[Docket No. 2000-SW-13-AD; Amendment 39-12132; AD 2001-04-13]

Airworthiness Directives; Eurocopter France Model SA.315B, SA.316B, SA.316C, SE.3160, and SA.319B Helicopters

ACTION: Final rule.

Figure 1

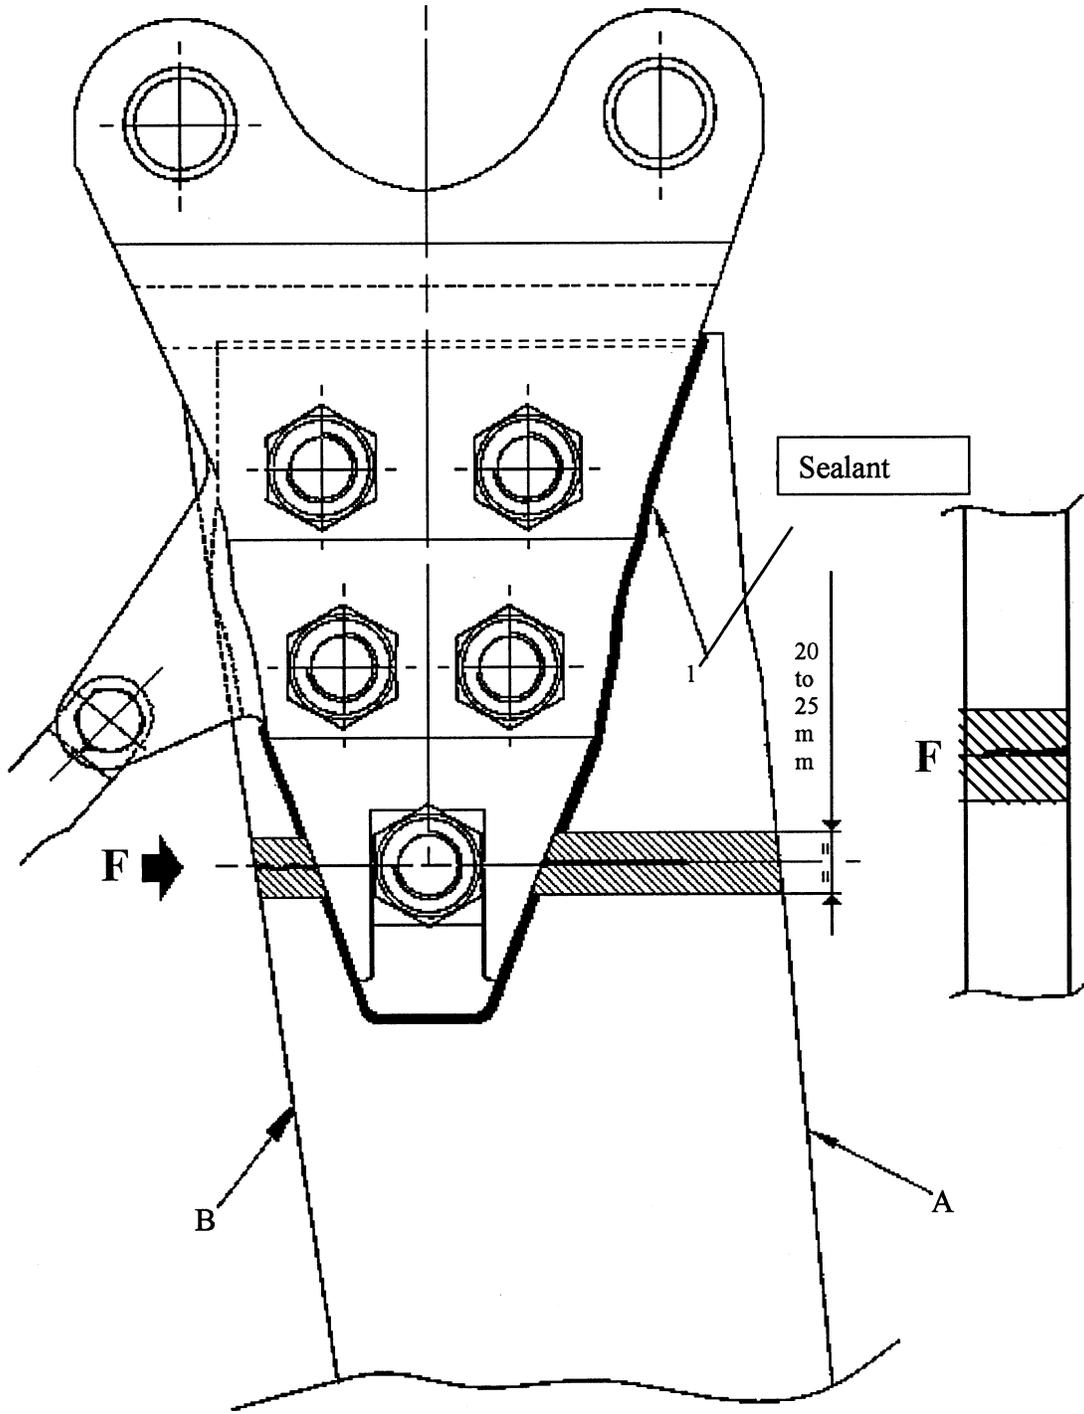
(iii) By either a dye penetrant or eddy current method, inspect each blade along the hatched area indicated in Figure 1, beginning on the blade lower surface, then on the flat section of the trailing edge (B), on the blade upper surface, and then on the flat section of the leading edge (A).

(2) Ensure that there is a sealant bead (1) around the edge of each blade cuff. If no sealant bead exists or if a sealant bead shows excessive wear, before further flight, apply a sealant bead in accordance with paragraph 2.2 of the Accomplishment Instructions of Eurocopter France SB 65.137 R1, dated November 17, 1993.

(iv) If a crack is found, replace the blade with an airworthy blade before further flight.
